**From:** Hurley, Joseph  
**Sent:** Thursday, March 2, 2023 9:37 AM  
**To:** Jenkins, Michael <[Michael.Jenkins@seattle.gov](mailto:Michael.Jenkins@seattle.gov)>; Buker, Gerald <[Gerald.Buker@seattle.gov](mailto:Gerald.Buker@seattle.gov)>; Barnett, Beverly <[Beverly.Barnett@seattle.gov](mailto:Beverly.Barnett@seattle.gov)>; Wilburn, Bradley <[Bradley.Wilburn@seattle.gov](mailto:Bradley.Wilburn@seattle.gov)>; Whitson, Lish <[Lish.Whitson@seattle.gov](mailto:Lish.Whitson@seattle.gov)>  
**Cc:** DuBois, Jeanette <[Jeanette.DuBois@seattle.gov](mailto:Jeanette.DuBois@seattle.gov)>; Capestany, Tina <[Tina.Capestany@seattle.gov](mailto:Tina.Capestany@seattle.gov)>  
**Subject:** RE: 1000 NE 45th Street alley vacation analysis - check in

**Subject:** 1000 NE 45th Street alley vacation analysis - check in

**Project:** 1000 NE 45th  
**Type:** Partial alley vacation  
**Phase:** Public Trust Review  
**Previous Reviews:** Pre-petition review – 6/9/2022  
**Presenters:** Tim Bates, Sound Transit; Abel Pacheco, Sound Transit; Jeremy Febus, KPFF Engineers; Beverly Barnett, Seattle Department of Transportation (SDOT)  
**Attendees:** Jeanette DuBois, SDOT; Lish Whitson, Seattle City Council

## Vacation & realignment

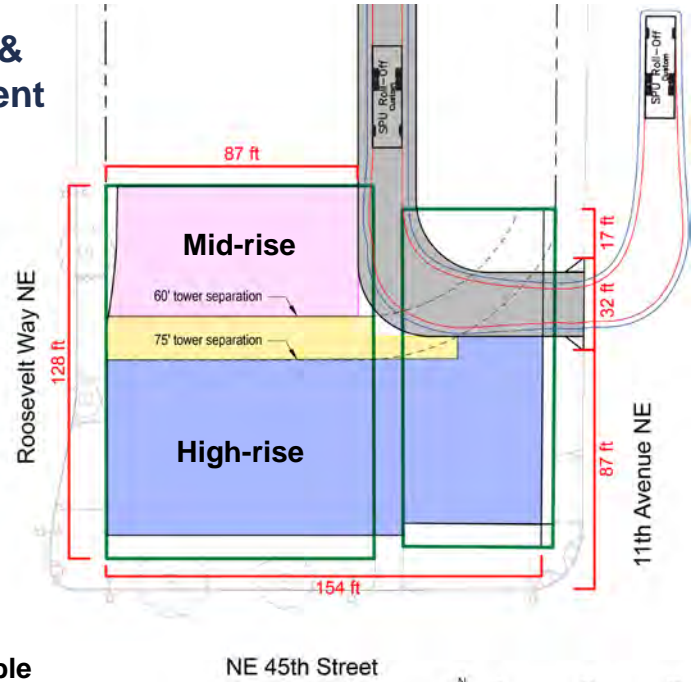
Good meeting yesterday, and great outcome! As the document was being presented by ST, Eddie and I noticed that the Vacation/highrise graphic (p.13 in PDF and cut/pasted by me below) did not show the at-grade neighborhood open space that would be 'required' to exceed the sites maximum FAR (which a highrise would require, per Eddie's notes, also pasted by me below). In the interest of not complicating the SDC's process (this info would likely only make the Vacation proposal better/more attractive), Eddie and I decided not to bring this up at the meeting, but perhaps it would be good to revise/include this info for the presentation

### Alley vacation impact: Buildable area

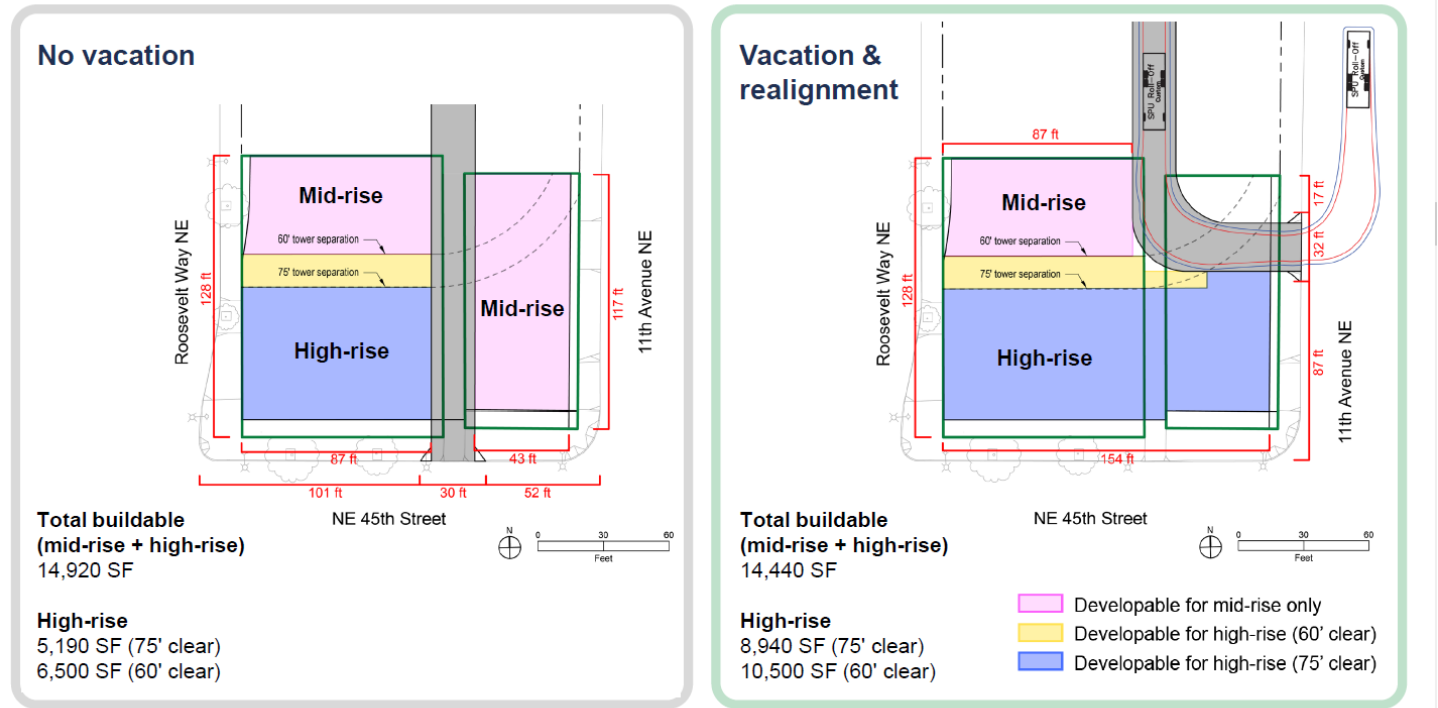
The following image illustrates buildable area on the site, for either midrise or high-rise development, along with the location of a future connection to 11<sup>th</sup> Ave NE

### Public trust: Circulation & access

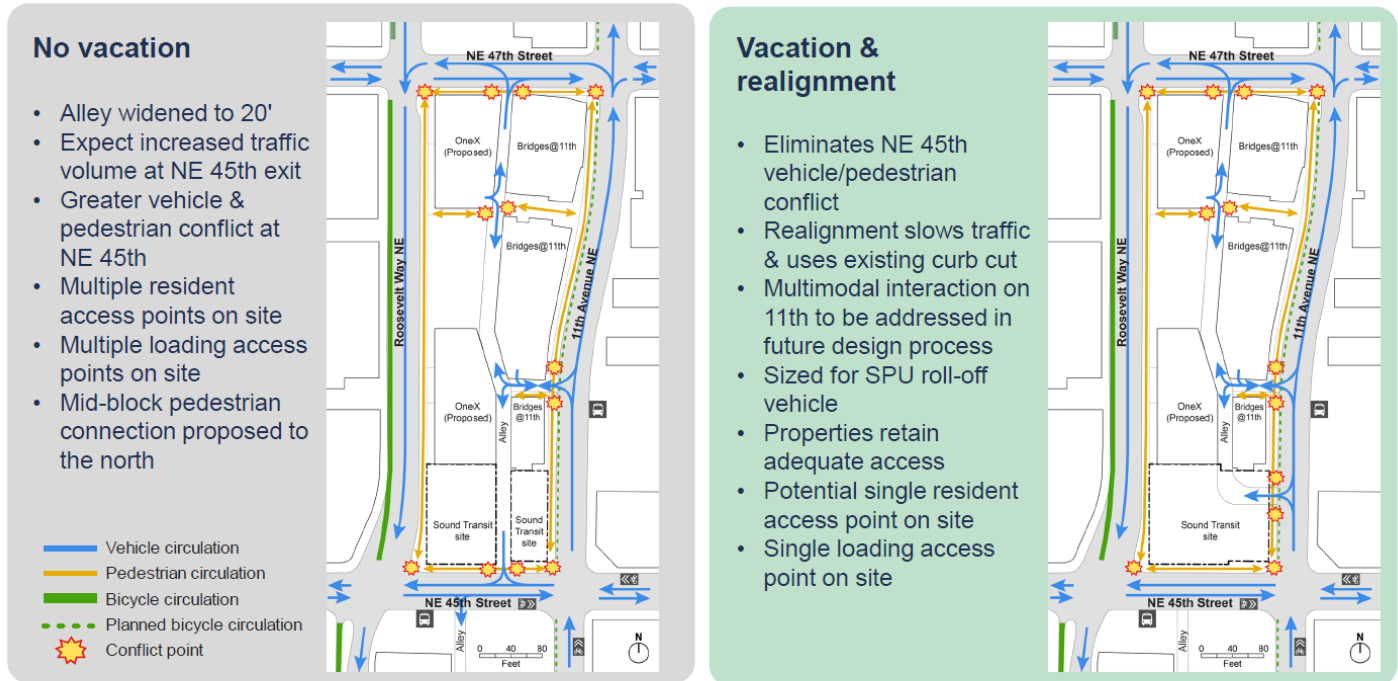
Commissioners focused their comments on how vehicles and pedestrian circulation will occur in a safe manner from the new alley configuration. Commissioners also focused their comments on where the location of “back of house” functions (trash, drop offs, deliveries, move-ins) from the vacation. Commissioners raised concerns about the potential impact to Protected Bike Lanes (PBL) planned for west side of 11<sup>th</sup> Ave NE and how those conflicts will be mitigated when a development is selected in the RFP process.

Prior to applying for a Master Use Permit, present to the SDC the design of the access point of the alley to 11<sup>th</sup> Ave NE. The commission will evaluate how the proposal minimizes functional impacts to circulation and access from moving vehicular access to 11<sup>th</sup> Avenue NE. The Commission will also evaluate how potential conflicts with pedestrians and cyclists on 11<sup>th</sup> Ave NE are addressed through planning and design solutions that improve safety such as:
